Access Compliance Report

Public Rights-of-Way

Intersection ID: 43362	Main Street: PROSPERITY_VIEW_DR	Cross Street: RIDGE_RD	Location: NE
ADA ID: 4FFE3BEE15CE	Ramp Type: Perp	Initial Pass/Fail: Pass	Overall Compliance: No
Severity Score: 2.5			
Codes/Mitigation Info/Possible Solution		Field Measurements/Component Compliance

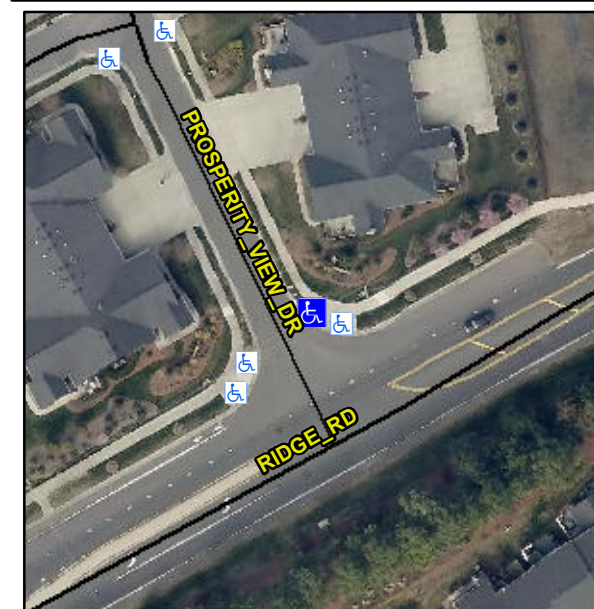
Remove & Replace Detectable Warning System. Remove & Replace Gutter.

R305.1.4, R304.5.3
